**TOWN OF WINTER PARK
PLANNING COMMISSION
Tuesday, April 26, 2022 8:00 AM**

TO Planning Commission
FROM Hugh Bell, Planner
THROUGH James Shockey, Community Development Director
DATE April 26, 2022
RE Single-Family Detached Design Review – Lot 12A, Whiting Tracts – 499 Kings Crossing Road (PLN21-126)

TO Planning Commission
FROM Hugh Bell, Planner
THROUGH James Shockey, Community Development Director
DATE April 26, 2022
RE Amendment to Design Review Single-Family Attached – Lots 9-18, Block 5, Roam Subdivision Exemption No. 3 – 13-49 Ski Idlewild Road (PLN20-045)

2 SIDE ELEVATION A
1/4" = 1'-0"

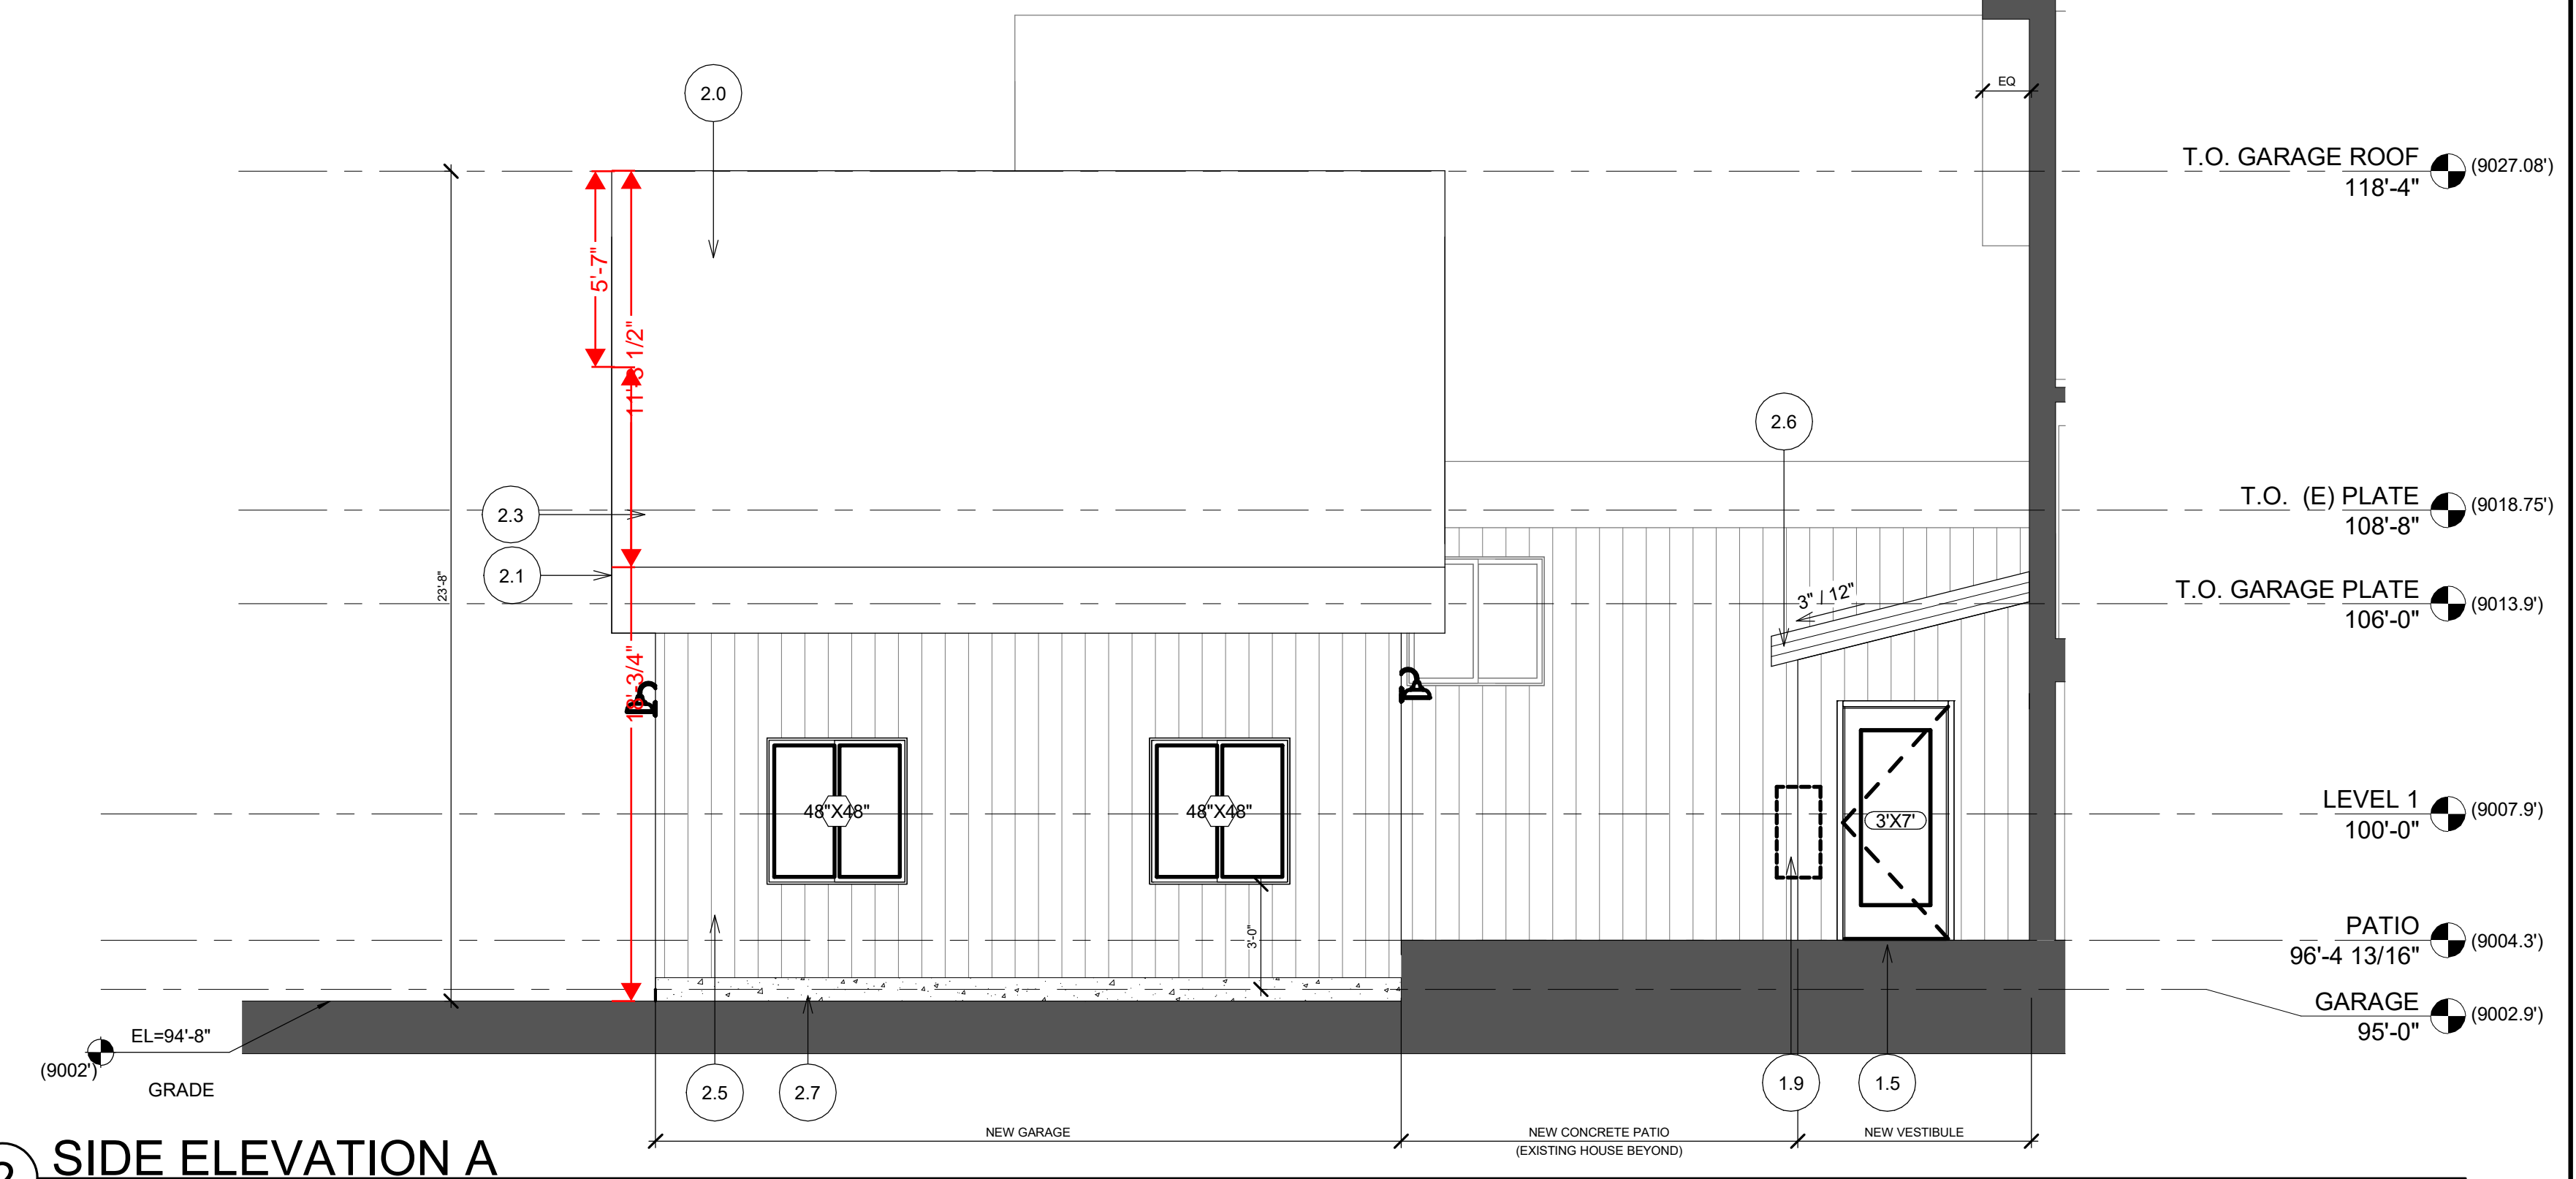
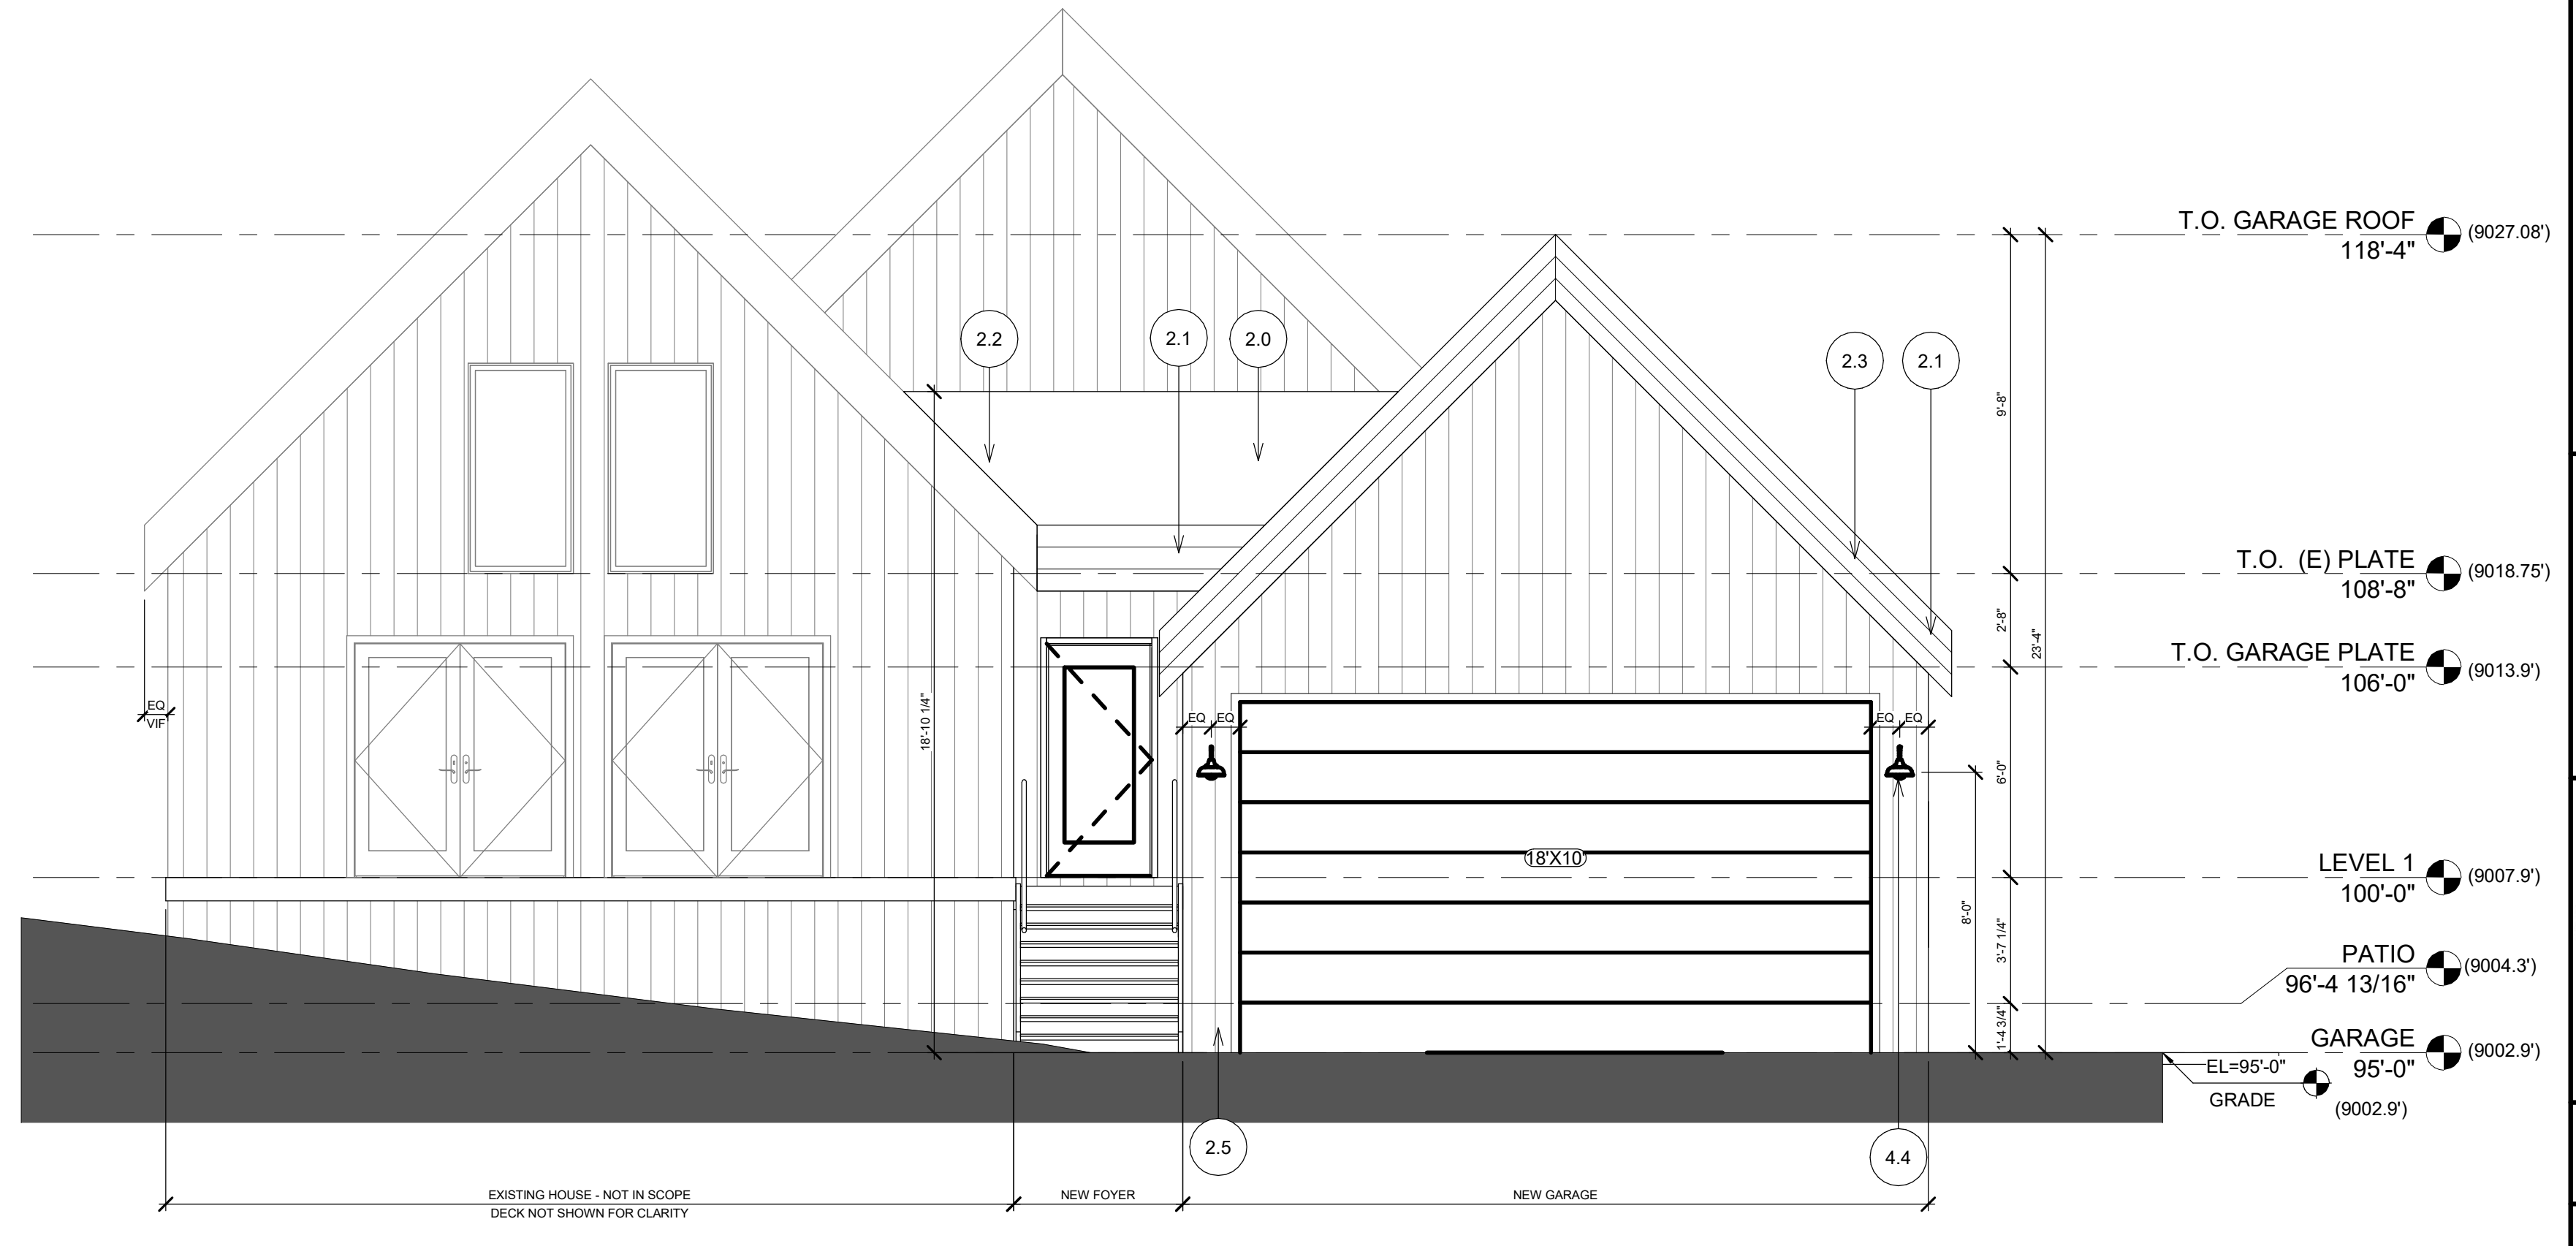
Unsatisfactory. Only proposed grade is depicted on elevation drawings. It appears the building is well under the maximum permitted midpoint building height of 35' but revised elevations will be necessary for staff to confirm.

1 SITE PLAN
 1/16" = 1'-0"

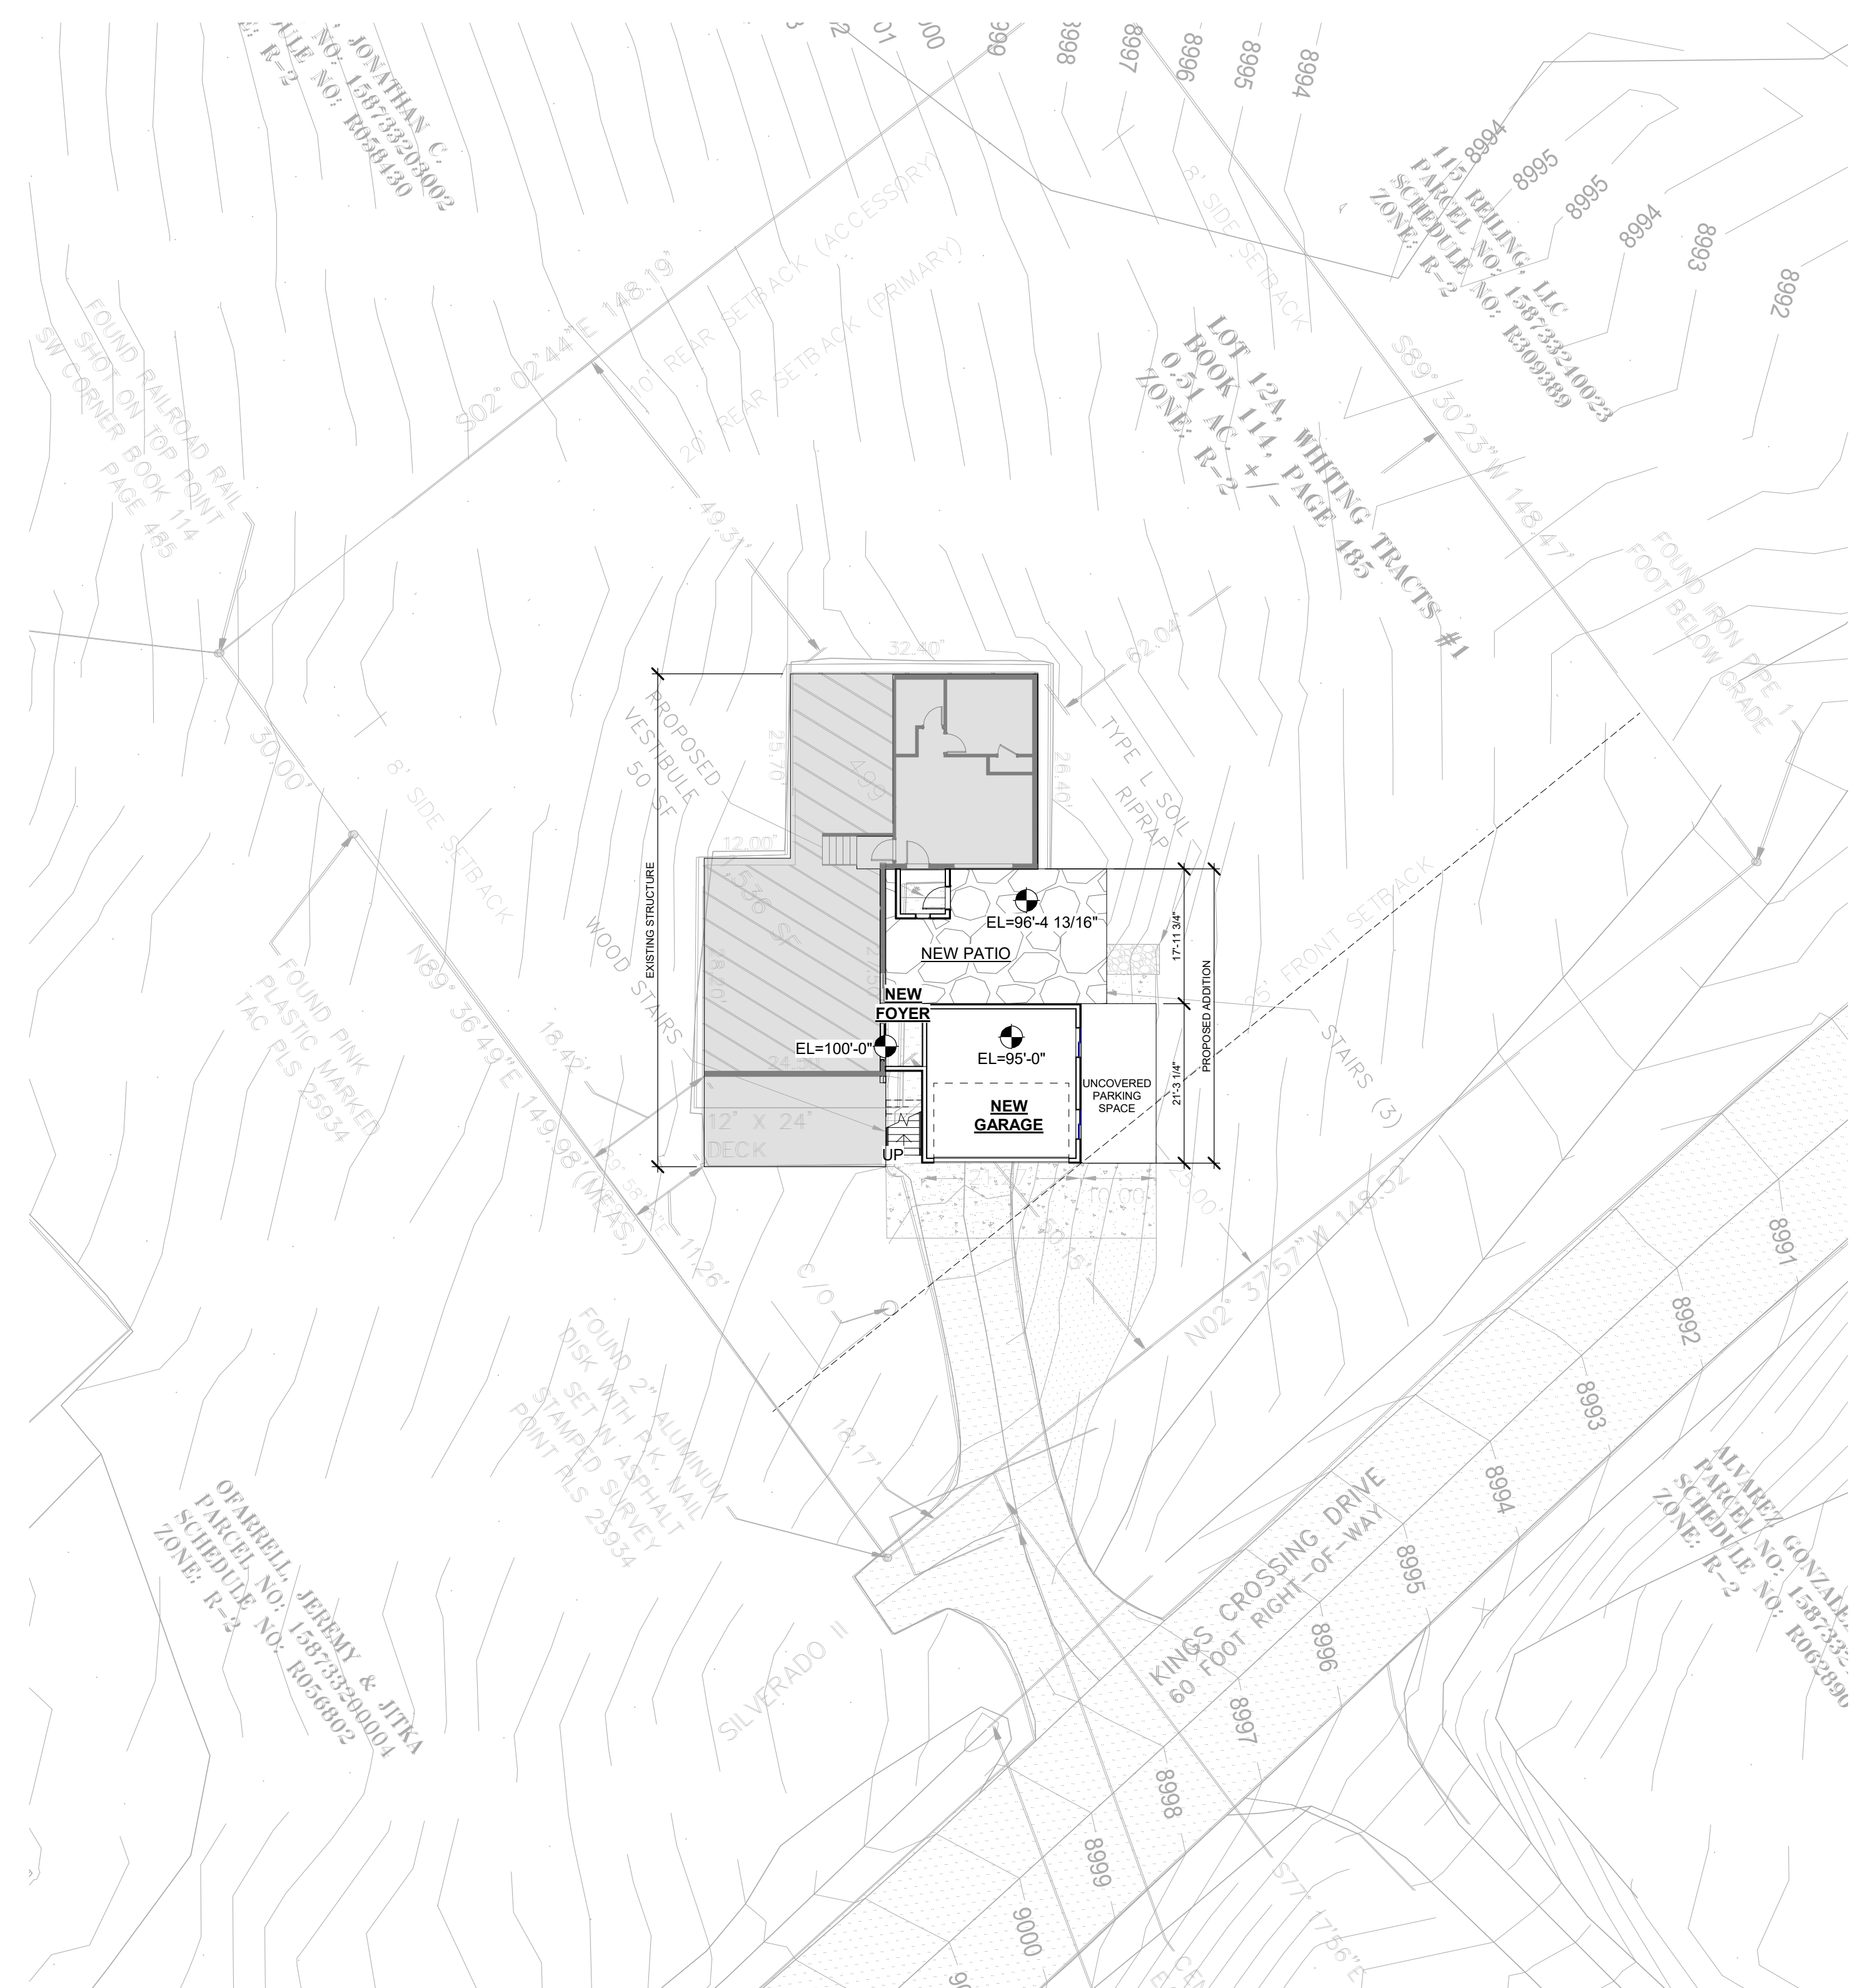
Unsatisfactory. 188 sq. ft. (25%) are required but snow storage is not depicted on a site plan exhibit. Calculation is taken from total asphalt area dimension. 3.11 of the Standards requires that a minimum of 25% of all driving surfaces (including gravel shoulders), parking areas, and pedestrian walkways is provided as snow storage.

- Applicant shall add proposed snow storage areas to a site plan exhibit for staff's review.
